Comments on
**Consideration of Environmental Impacts on
Temporary Storage of Spent Fuel After Cessation of
Reactor Operation**

Docket ID No. NRC-2012-0246:

**“The inadequacy of NRC’s Proposed Ruling
on the storage of irradiated nuclear fuel”**

Figure 1. Historical and Projected Average BWR and PWR Discharge Burnups
(Source: Supko/EPRI 2012)

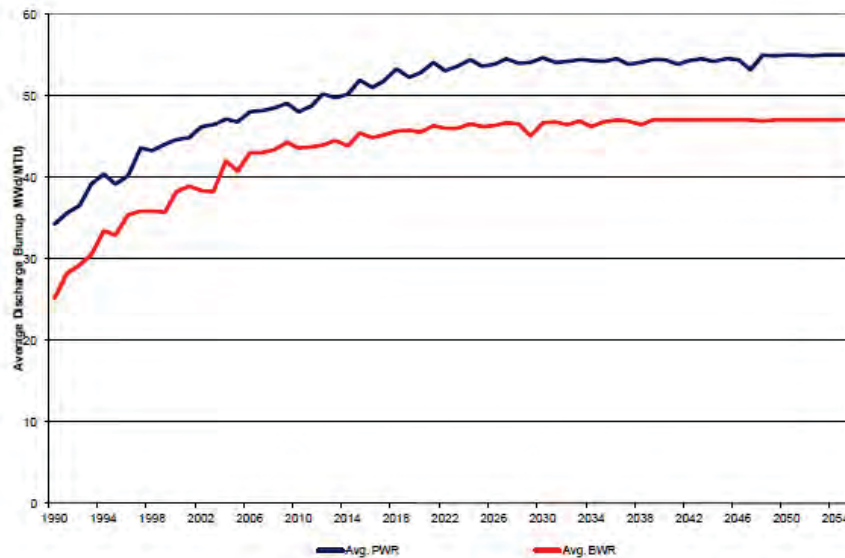
Reactor fuel burnups have gradually increased on the average to ~50 GWd/t for Pressurized Reactors (PWR) and 43GWd/T for Boiling Water Reactors (BWR).¹ Projected burnups are estimated to increase. (See Figure 1) The current maximum peak burnup limit is 62MWd/t. Reactor operators would like to increase burnups to 75GWd/t..² As of 2008, the NRC allows reactors using uranium fuel to operate at the highest burnup rates of any country in the world.³
